SERVICE BULLETIN

MODEL NAME : Di620
MODEL CODE : 1155
NO. : 018C
DATE : 981215
SUBJECT : STATUS MONITOR DISPLAY FAILURE

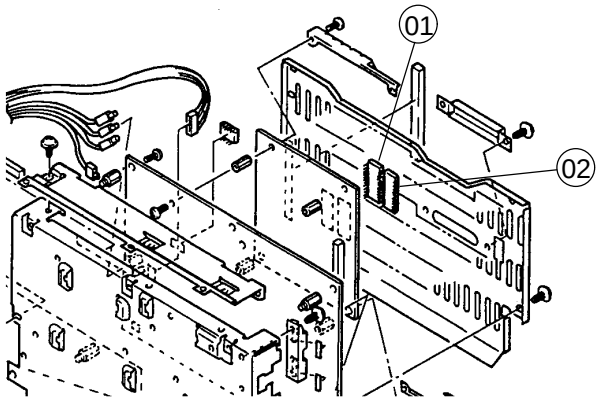
PROBLEM: In the machine equipped with the Pi6000, if a malfunction condition or paper jam occurs while the data from the personal computer is printed out, the machine conditions may not be indicated in the Status Monitor on the display of the PC.
CAUSE: There is a software bug.
SOLUTION: The software program of IC2W (02) and IC3W (01) on PWB-W has been changed.
